Final Environmental Impact Report  
for the

# Main Street Cupertino Project

SCH# 2008082058

December 2008

PARKING GARAGE ELEVATION - LOOKING SOUTH

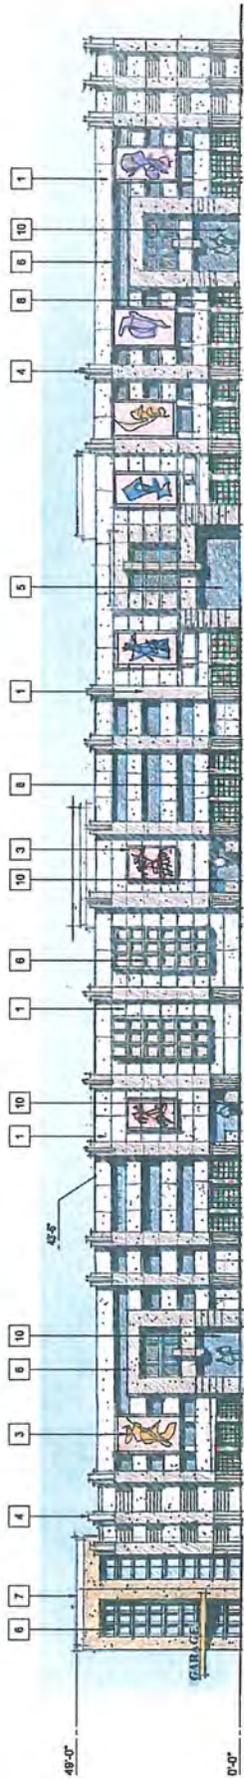
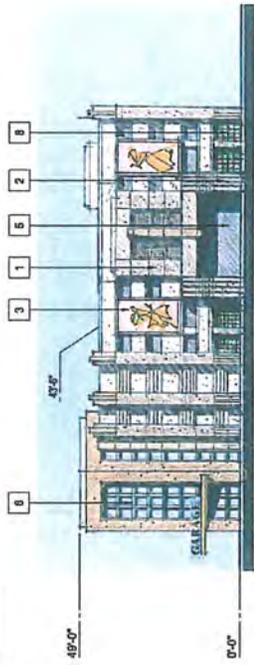
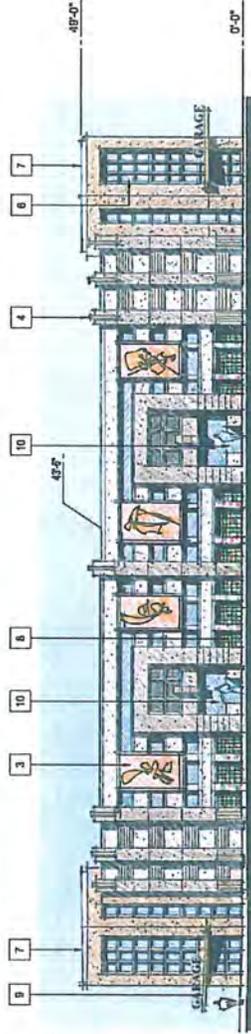
**Comment 7.14:** Apple is concerned that the garage design not contribute to Vallco Parkway feeling like a lifeless "back alley," conflicting with the City's streetscape goals and policies. By way of example, the proposed parking garage appears inconsistent with Policy 2-14, Strategy 3 of the General Plan, as indicated on page 112 of the DFEIR: "Building and Site Design Strategy 3: Parking Placement in New Development. Place parking out of sight, behind or underneath buildings." The two development schemes propose a total of either 1,520 or 1,830 parking spaces, with the vast majority, or 1,100 of those spaces, in the 5-story parking garage fully visible above grade.

**Response 7.14:** As discussed in on page 112 of the Draft EIR, the parking for the project (under either scheme) would be providing in surface parking lots, above and below ground parking garages, and on-street. In both schemes, the proposed surface parking lots are located in the interior of the site, shielded from view from Stevens Creek Boulevard and Vallco Parkway by proposed buildings. Both project schemes include a multi-story parking garage above ground along Vallco Parkway. The proposed above parking garages in either scheme would have existing and proposed landscaping and architectural details that would soften the views of the parking garage. For these reasons, the project is considered consistent with this strategy. See also **Response 7.13** above.

FIGURE 1.0-3 (REVISED)

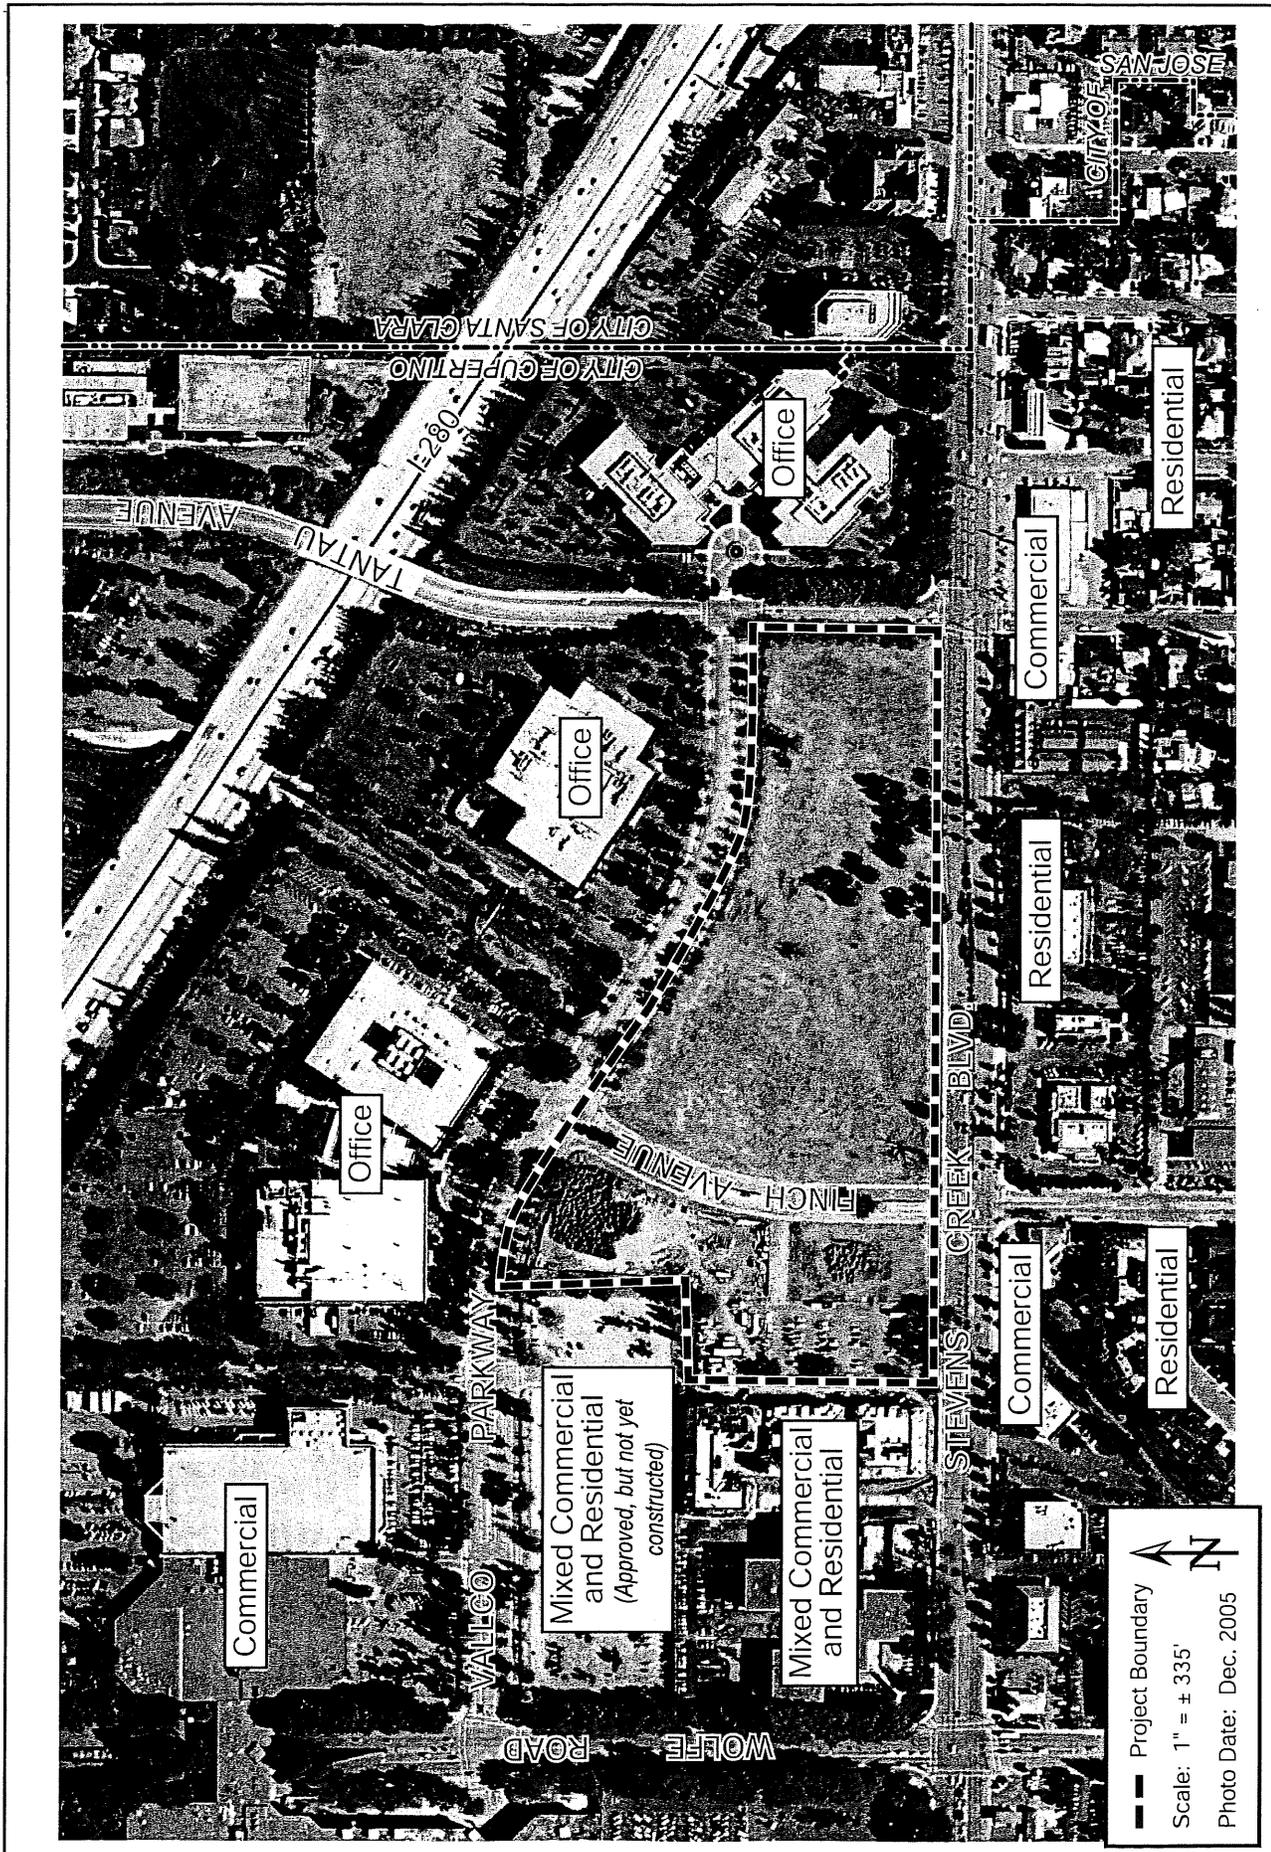
**Comment 6.1:** Figure 1.0-3: Please identify the City of Cupertino/City of Santa Clara border on the aerial photograph.

**Response 6.1:** Figure 1.0-3 has been revised to show the City of Cupertino/City of Santa Clara border, refer to the text revisions of the Draft EIR in **Section 5.0** of this Final EIR.

Replace Figure 1.0-3 with Revised Figure 1.0-3 on the following page.

**FIGURE 1.0-4 (REVISED)**

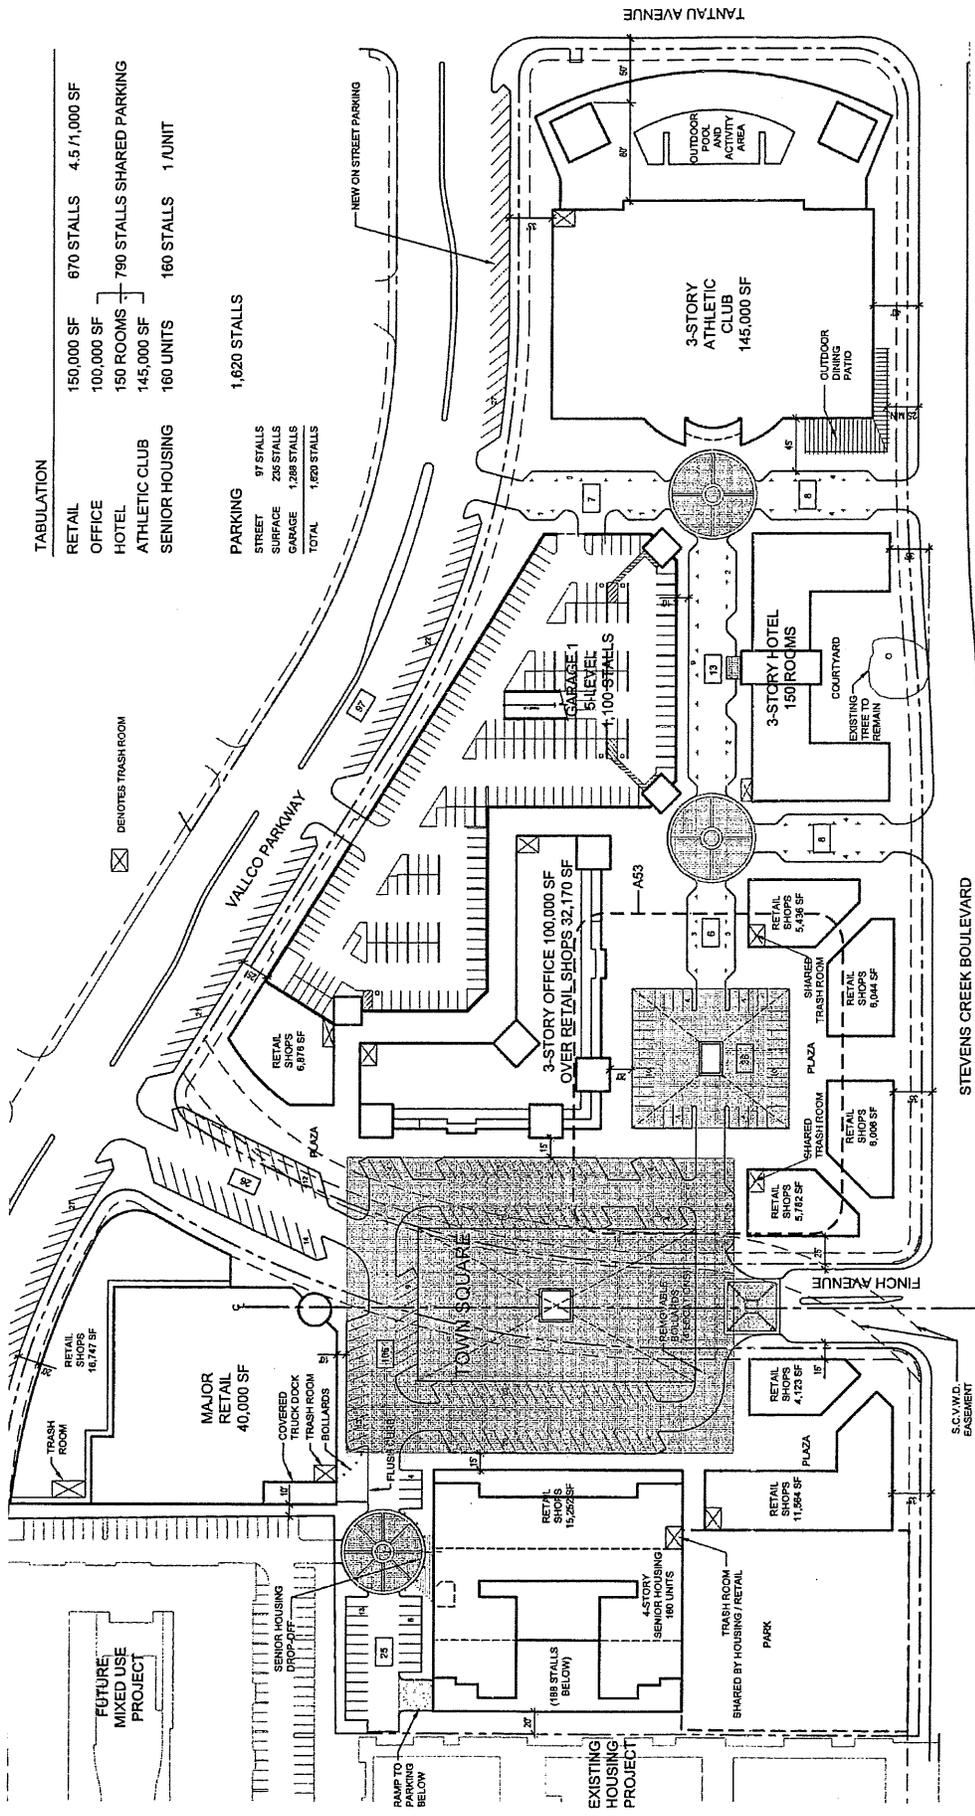
The project (under both schemes) proposes to narrow Vallco Parkway along the project site frontage from six lanes (three lanes in each direction) to two lanes (one lane in each direction) and add angled parking on the south side of Vallco Parkway along the project site frontage. ~~In addition, the project (under both schemes) proposes to add parallel parking spaces on the north side of Stevens Creek Boulevard along the project site frontage (see Figures 1.0 4 and 1.0 8).~~

**Response 7.10:** The project does not propose to modify existing off-site access points on Vallco Parkway. In addition, the site plan has been revised to clarify that no diagonal parking is proposed on the north side of Vallco Parkway (refer to revised Figures 1.0-4 and 1.0-8 in **Section 5.0** of this Final EIR). For these reasons, access to off-site properties along Vallco Parkway would not be adversely affected by the project.

Replace Figure 1.0-4 with Revised Figure 1.0-4 on the following page.
